Model: ARDF DF3090		Date: 30-Oct-14	No.: RD779002
Subject: Parts Catalog Correction		Prepared by: Y.Kuwabara	
From: Improvement for reverse feeding in ARDF			
Classification:	<input type="checkbox"/> Troubleshooting <input type="checkbox"/> Mechanical <input type="checkbox"/> Paper path <input type="checkbox"/> Product Safety	<input checked="" type="checkbox"/> Part information <input type="checkbox"/> Electrical <input type="checkbox"/> Transmit/receive <input type="checkbox"/> Other (     )	<input type="checkbox"/> Action required <input type="checkbox"/> Service manual revision <input type="checkbox"/> Retrofit information <input type="checkbox"/> Tier 2

Model: ARDF DF3090		Date: 16-Jan-15	No.: RD779003
Subject: Poor stacking on ARDF DF3090 original exit tray		Prepared by: E.Hinata	
From: 1st Tech Service Sect., MFP/P Tech Service Dept.			
Classification:	<input checked="" type="checkbox"/> Troubleshooting <input type="checkbox"/> Mechanical <input type="checkbox"/> Paper path <input type="checkbox"/> Product Safety	<input type="checkbox"/> Part information <input type="checkbox"/> Electrical <input type="checkbox"/> Transmit/receive <input type="checkbox"/> Other (     )	<inpu

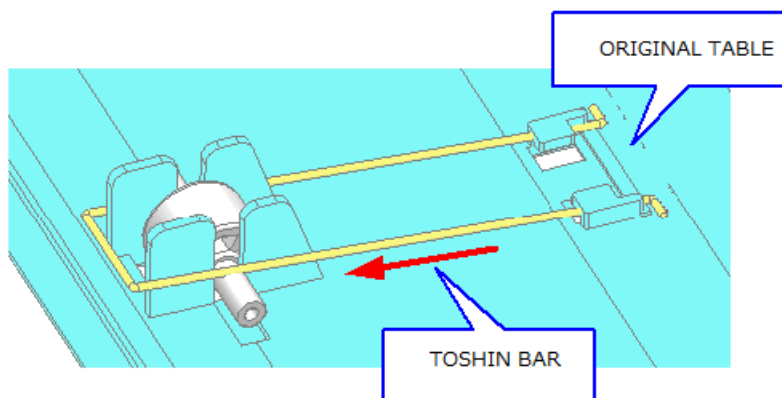
### Change:

- 1) Added a fixed-position rib to the original table.
- 2) Lengthened the TOSHIN BAR.

**Reason:** To further improve ARDF reverse feed performance.

1. Attach the TOSHIN BAR and pull in the direction of the red arrow.
2. Attach the rib to the original table.

## SYMPTOM

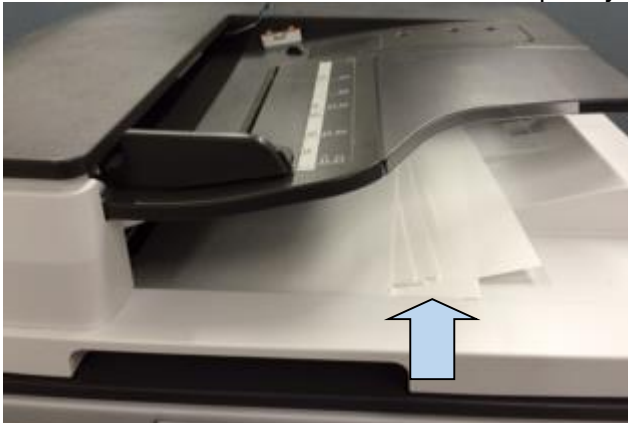
Originals fed from ARDF DF3090 are stacked poorly on the original exit tray.

- Originals are designed to exit slightly faster as soon as scanning completes.
- The original exit tray is not level between the operator and non-operator sides.

## SOLUTION

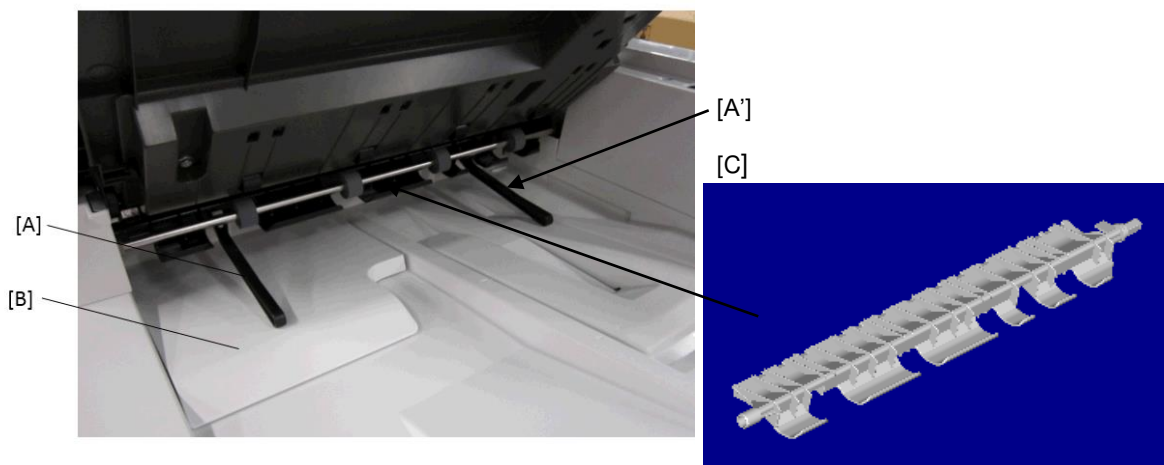
1. Added one more paper exit lever.  
**Note:** The photo below shows the existing exit lever [A'] and additional exit lever [A].
2. Added an auxiliary tray [B].
3. Modified the gate pawl [C] (to enable addition of a lever).

### 2. Add the lever [A] and tray [B], and replace with the gate pawl [C].

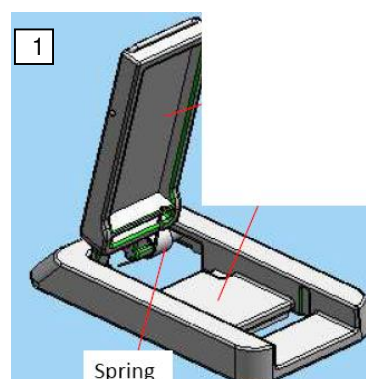
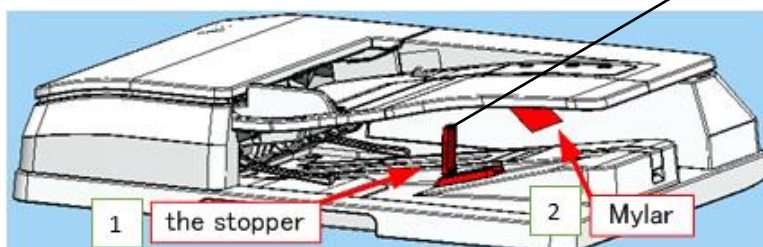
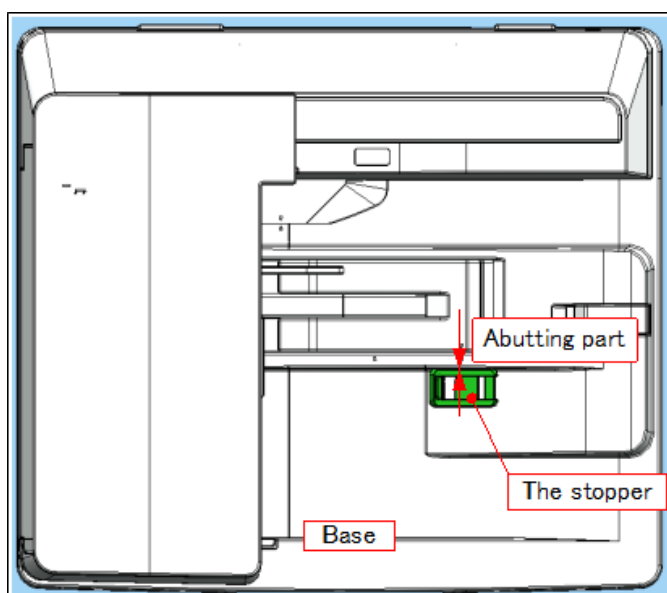
If poor stacking still occurs with A4/LT LEF, attach the following parts.

Attach stopper [1] and Mylar [2] (See **Procedure** below).

#	Part number	Description	Function
1	D6849502	UNIFORM UNIT:PAPER EXIT SUB-UNIT:ASS'Y	Stops the leading edge of <u>A4/LT LEF</u> for higher stacking performance. The stopper will automatically collapse by its spring when feeding A3/DLT originals.

1. Peel off the adhesive covering (paper) from the stopper.
2. Attach the stopper to the ramp as shown in the diagram.

**Important:** Make sure the long end of the stopper is flush against (touching) the side of the paper exit sub-unit, as shown.

## SYMPTOM

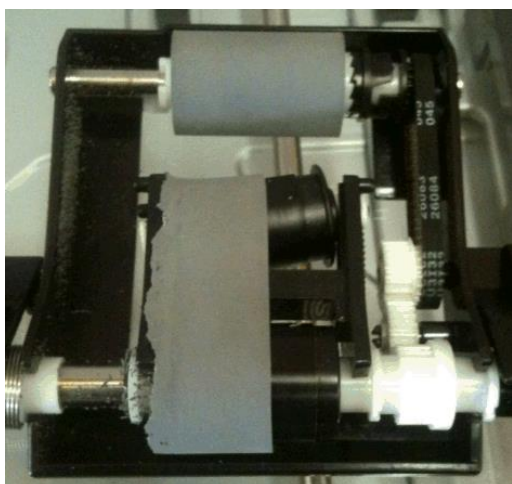
The thread in the feed belt comes apart. Eventually, the belt is torn.

When a user pulls jammed paper forcibly toward the front or rear side of machine, the belt shifts to one side and goes over the flange of the roller.

Replace the feed belt (D5412121) with the modified part (D6842171).

With this part change, the material has been changed so as not to shift to one side easily.

## CAUSE

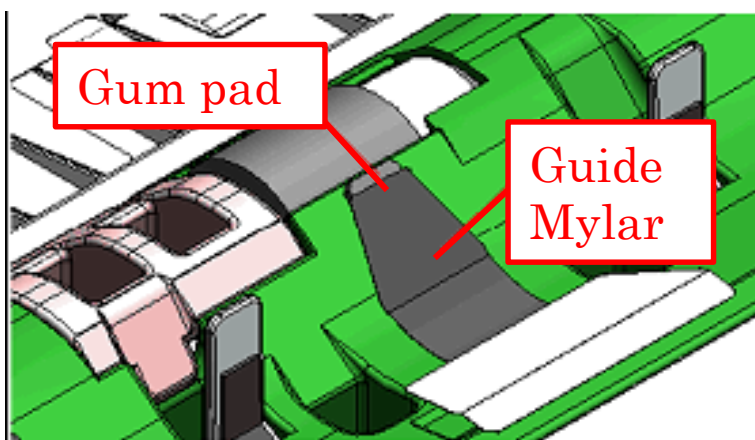
Multi-feeds may occur when feeding originals with the DF3030.

The friction between originals is too high for the friction pad to separate the sheets.

A rubber pad and guide Mylar were added.
